Statutory Consultees

Application number: 2022/0966/FUL

Location: 127 Yarborough Road, Lincoln, Lincolnshire, LN1 1HR

Highway and Lead Local Flood Authority Report

An extract of Drawing 8325B-PP2-01 is provided below which shows the location of the five brick pillars of the new boundary wall.

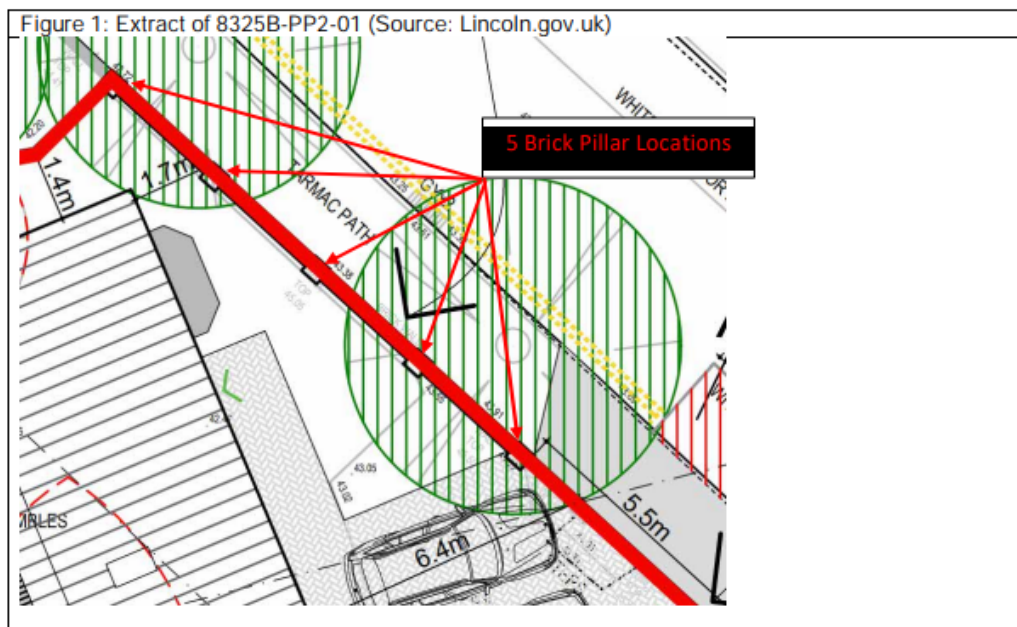
Upon further review it is quite clear that the street elevation plan (Drawing 8325B-PP2-03) is incorrect and misrepresents the relationship between the application site and our property (either that or the proposed site plan and boundary wall details are incorrect).

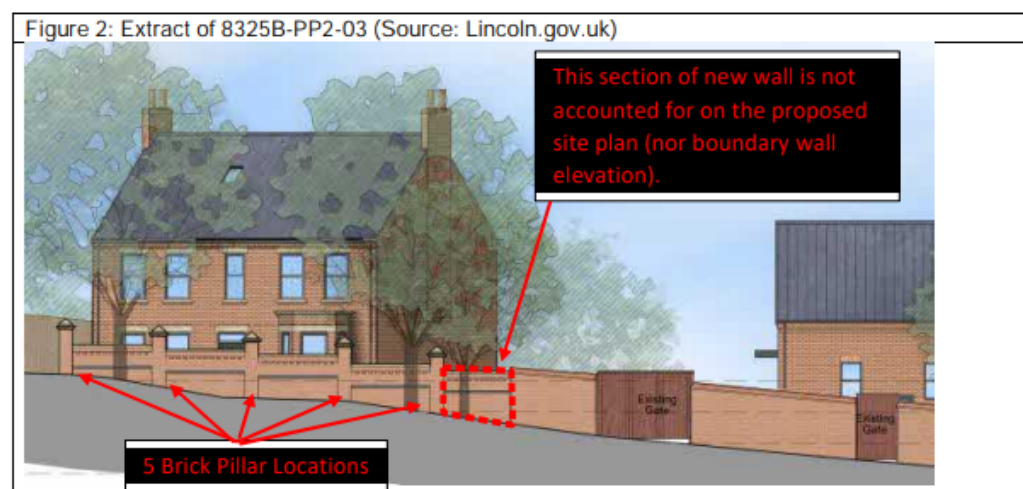
In comparison, an extract of 8325B-PP2-03 is provided below which also depicts the 5no. brick pillars. However, this plan also shows an extra section of wall which does not align with the proposed site plan (nor the boundary elevation drawing) because it would extend beyond the red line of the application site. As such, this extra section of wall provides an additional visual separation of c.2m on the 'Street Elevation' drawing. This completely misrepresents the proposed relationship between the application site and our dwelling, which, in fact, will be located substantially closer to our boundary than shown.

It is also questionable if the proposed dwelling is accurately located given the position in relation to the final brick pillar (again comparing 8325B-PP2-01 and 8325B-PP2-03).

Figure 3 – Street Scene Elevation Extract of 8325B-PP2-03 (Source: Lincoln.gov.uk)

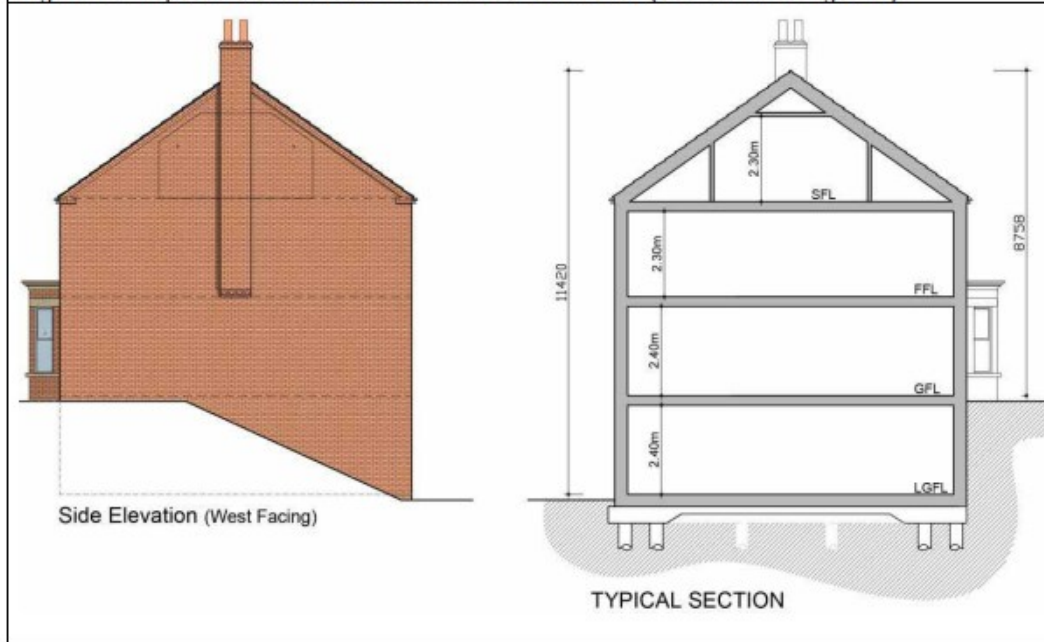
There is a significant change in levels along Carline Road and this can be viewed on the applicant's street elevation drawing (figure 3). It is quite clear that the application dwellings are situated on substantially higher land than my property. As stated above, the separation distance to our shared boundary is c.1.4m at the front of the building, extending to c.3m to the rear of the building. The height from ground level to the front of the dwelling is c.8.7 (ridge) (reduced from c.9.2m) and c.5.2 (eaves) and from ground level to the rear of the dwelling the height is c.11.4m (ridge) (reduced from c.11.9m) and c.8m (eaves).

Figure 4 – Proposed Side Elevation Extract of 8325B-PP2-02 (Source: Lincoln.gov.uk)

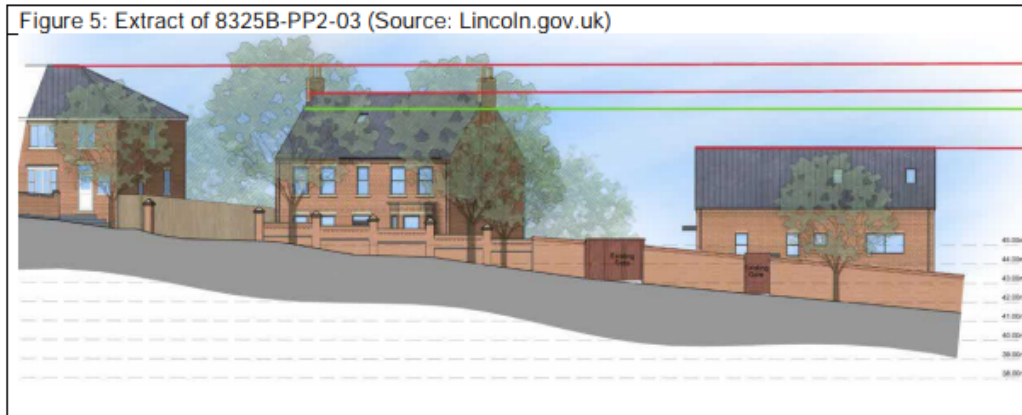
The elevation shown in figure 4 below will be experienced from between c.1.4m and c.3m from our shared boundary.

Specifically, we would like to emphasise that our ground floor bedrooms, terraced area and side garden, will be severely impacted through a loss of light if this development is allowed. Even in the summer months, the southern side of our property will clearly lose considerable light and will be mainly in shadow. We therefore consider that it should be a requirement of the planning process (and this application) to demonstrate robustly that this impact can be suitably mitigated. We strongly contend that it cannot.

When considering cumulatively, the positioning of the development to the boundary, the proximity to our dwelling, the height of the proposal and the change in levels, the revised proposal would still result in a significantly oppressive and overly dominant structure when viewed from our side garden area, first floor terrace and the habitable windows located on our south-eastern elevation. The proposed development would sit in close proximity to our site boundary to such an extent that there would be a sense of enclosing, overbearing and loss of light over our property.
